ADDENDUM NO. 3

TRACK & FIELD IMPROVEMENTS – INC 1

Hueneme High School

December 2, 2019

HUENEME HIGH SCHOOL
APP. 03-120007
ADDENDUM #3
REF. DWG.: C5.0
ISSUE DATE: 12/2/19
AD3-C1

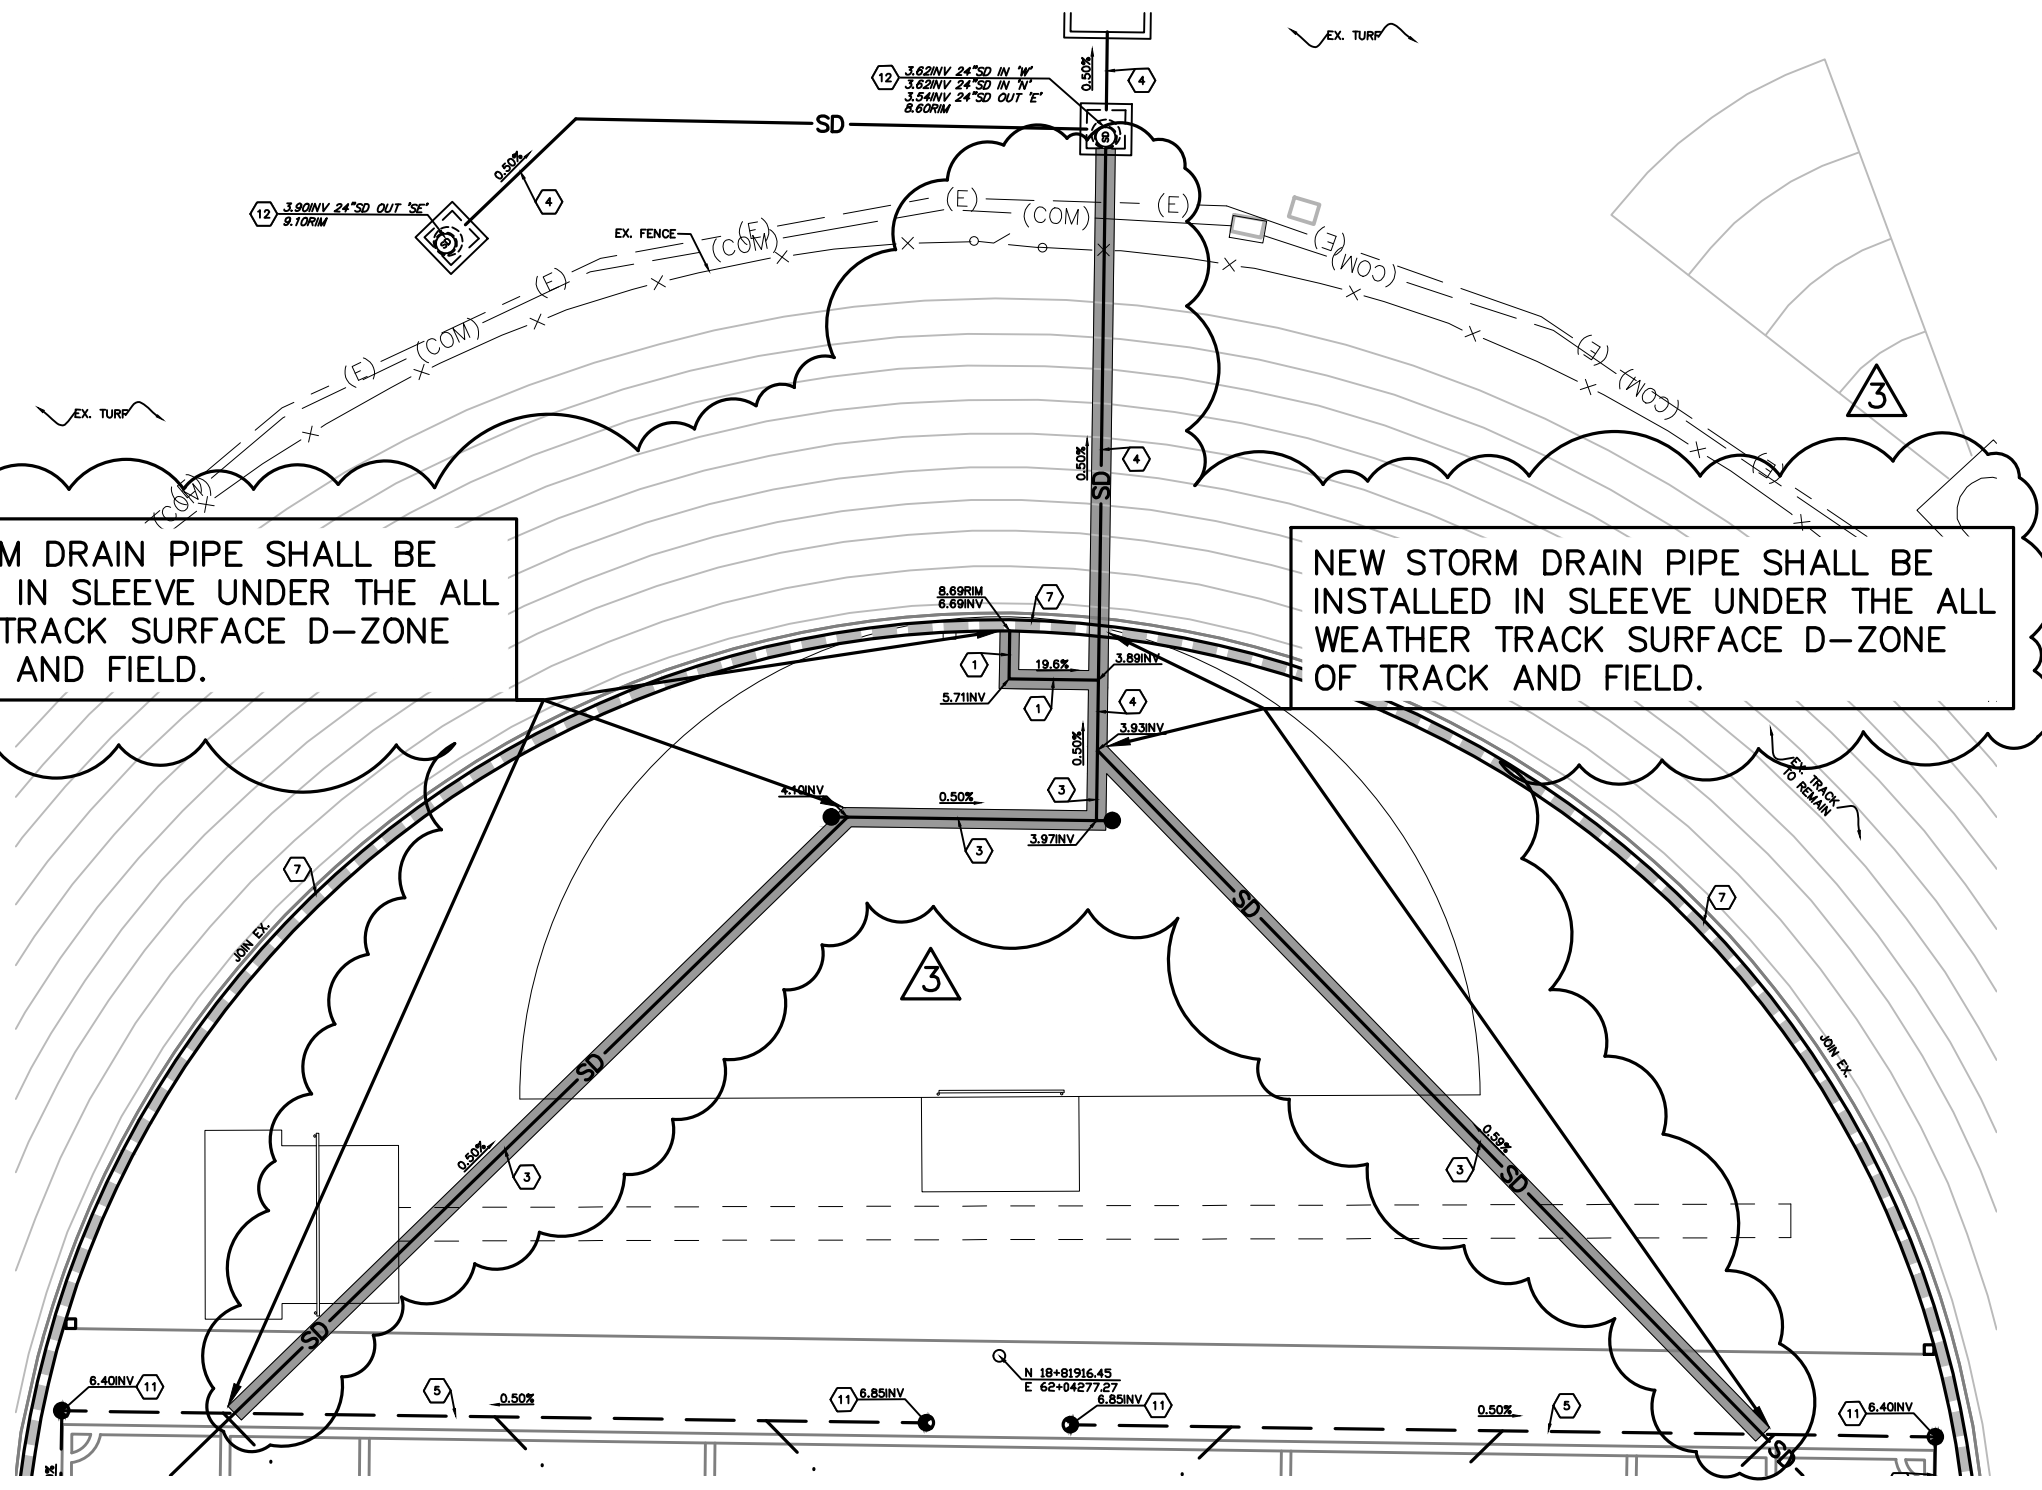
3.1.1.1. Drawing C-5.0/AD1-C3: Revise per Drawing AD3-C1.

NEW STORM DRAIN PIPE SHALL BE
INSTALLED IN SLEEVE UNDER THE ALL
WEATHER TRACK SURFACE D-ZONE
OF TRACK AND FIELD.

AD3-C2

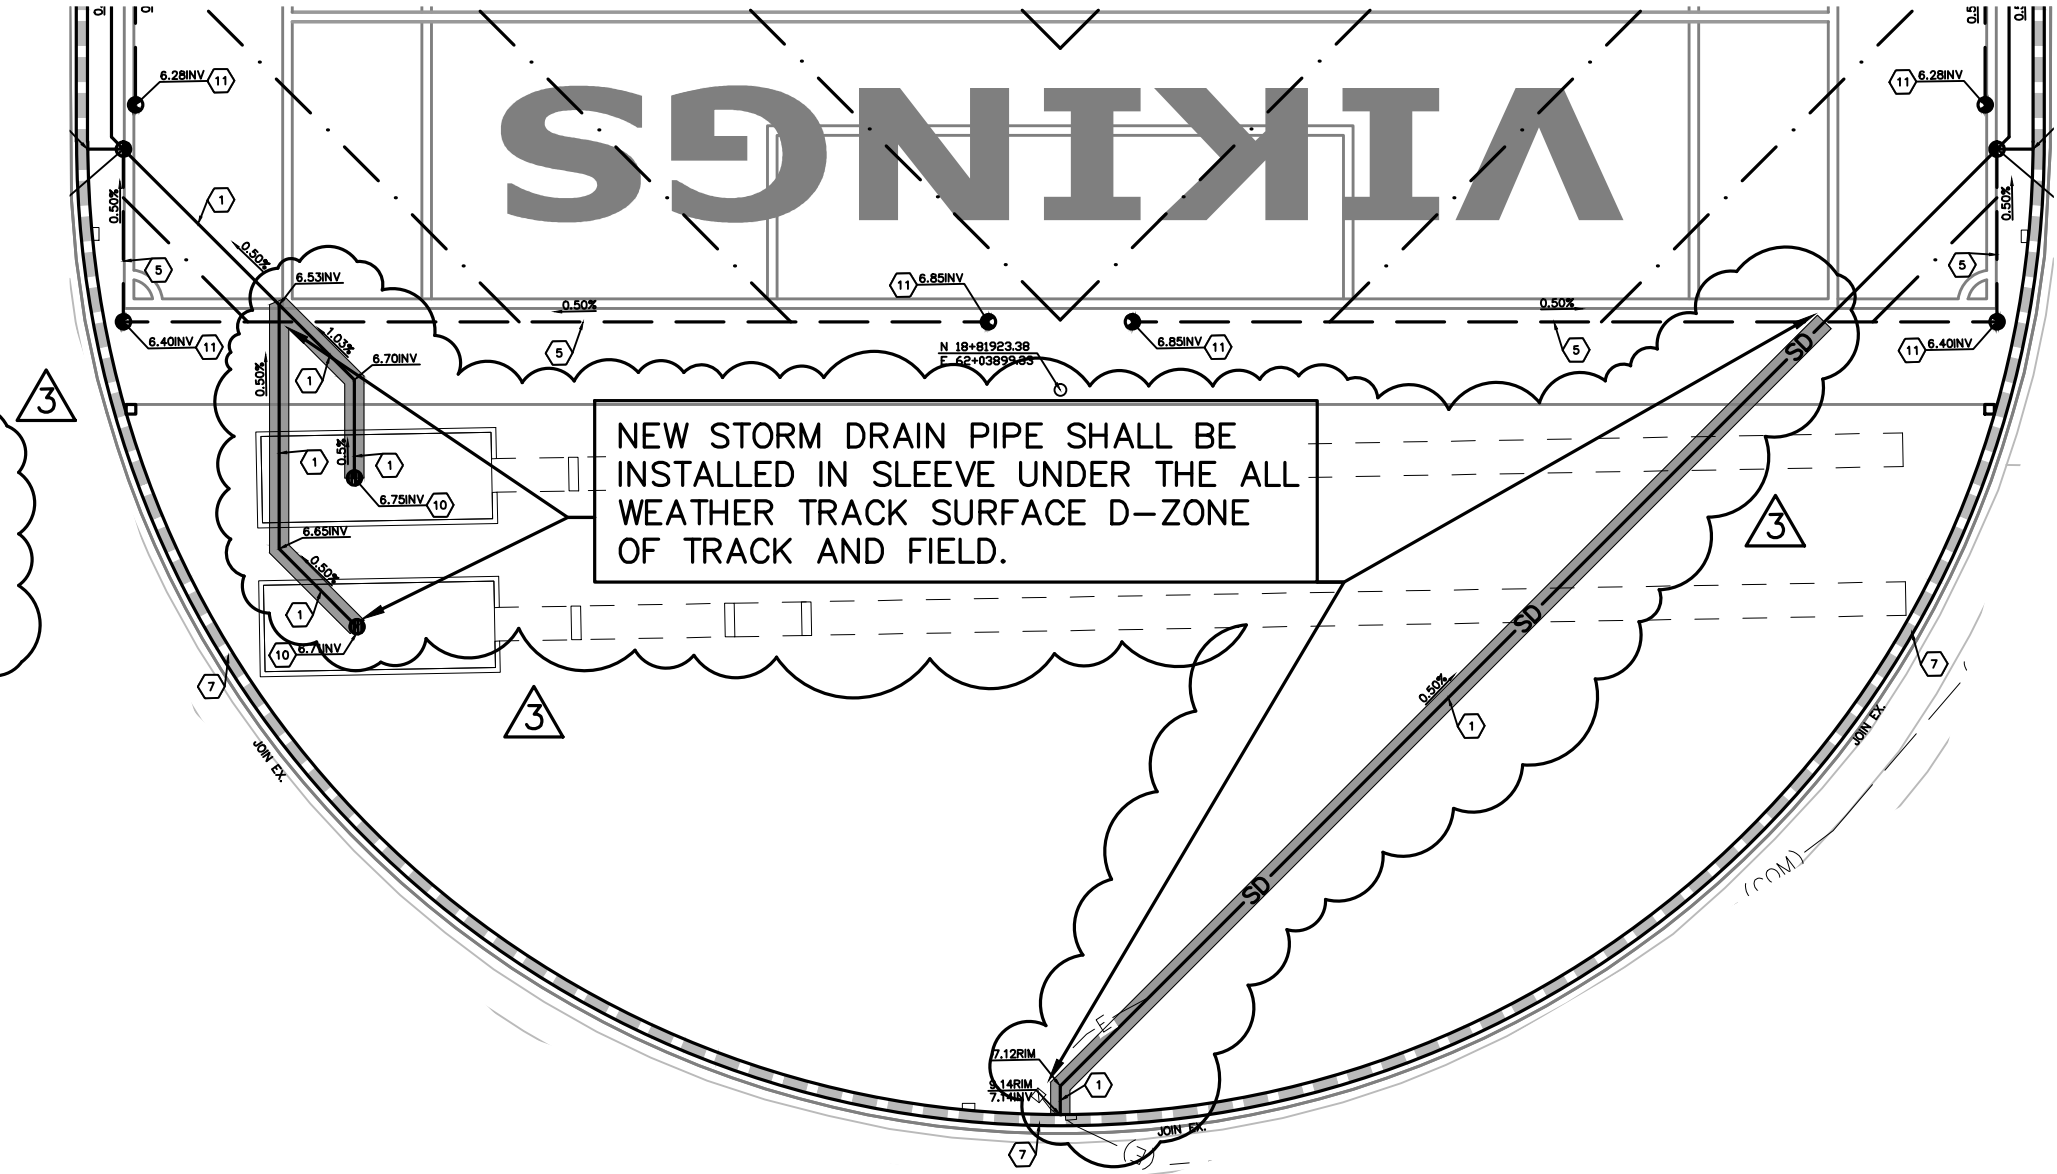
3.1.1.2. Drawing C-5.2: Revise per Drawing AD3-C2.
